TB-20111201

**Subject: The cancellation of 1/4" flare connector on motor casing of RC2 series compressor (model: RC2-170~RC2-930A/B, except RC2-180A/B)**

**Difference before and after engineering change:**

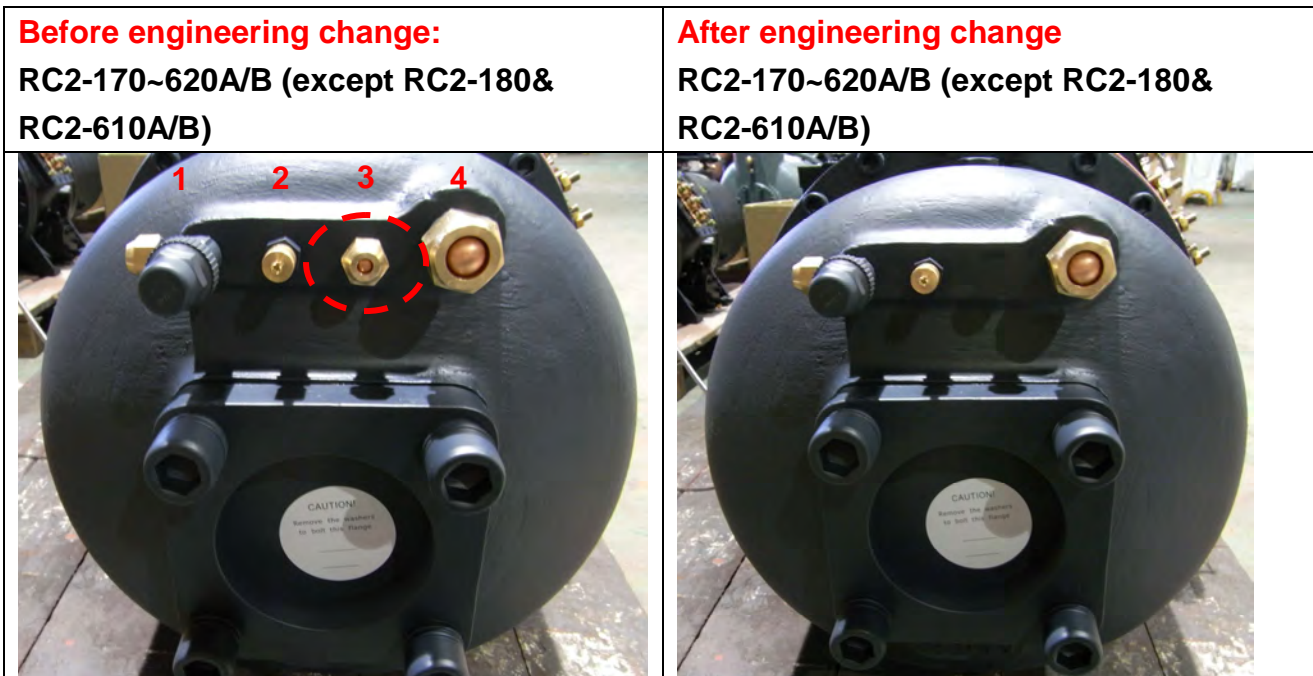
There is one 1/4" flare connector on motor casing of RC2 series compressor (model: RC2-170~RC2-930A/B, except RC2-180A/B). This connector is mainly for backup in its function, and from our survey results most of our customers and end-users seldom use it in chiller unit or in after service. The other three connectors on motor casing (angle valve, refrigerant service valve and liquid injection connector) are sufficient for application. Therefore, we will cancel this 1/4" flare connector on motor casing from 2012 (Compressor S/N: 2EXXXXX) without further notice.

No.	Name	No.	Name
1	Angle valve	3	<b>Connector (1/4" flare)</b>
2	Refrigerant service valve	4	Liquid injection connector

**Before engineering change:**  
RC2-610~930A/B (except RC2-620 A/B)

**After engineering change:**  
RC2-610~930A/B (except RC2-620 A/B)
